Product hierarchy no. *				Part no.	SBU	Type / Description	Customer part no.
SBU PG	PGU	Type					
02	006	016	0000001600	5145.XXXX	Power Entry Module with Filter	5145

2 Type of change

3 Detailed description of change

5145					0118.2221	
creation date	created by	release date	released by	notification no.	revision	page
2014-05-27	huberth	2014-08-13	schaidro	26198	-	1 of 3

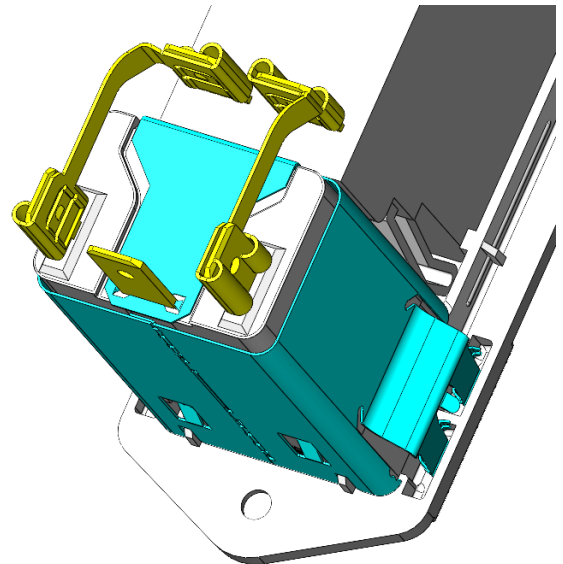
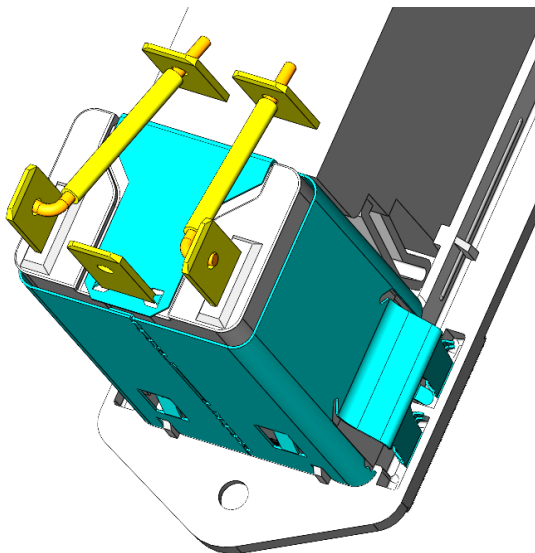
- a) Soldered wire connection between filter and circuit breaker replaced by faston connection.

Old version:

New version:

- a) Elimination of the critical soldering process on the quick connect terminal.
b) Consolidation of production sites.
